SECTION 904 - NOTICE TO BIDDERS NO. 7464

SUBJECT: Additional Pay Item

Bridge Repair on SR 30 over Tallahatchie River (Bridge No. 19.0), known as Federal Aid Project No. STBG-0044-01(036) / 109672301 in Union County.

ADDENDUM

WK. NO.
 DL-BR-1
 SHEET NO.
 8001

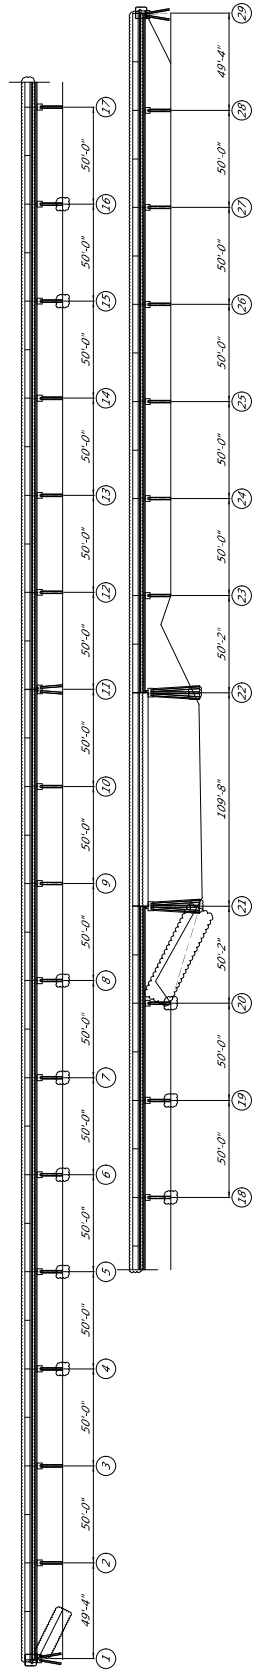
BRIDGE DIVISION		
REVISIONS		
DATE	SHEET NO.	DESCRIPTION BY
01/20/2026	8002	Revised quantities and epoxy repair locations AWH
01/20/2026	8007	Revised encasement locations, details, and notes AWH
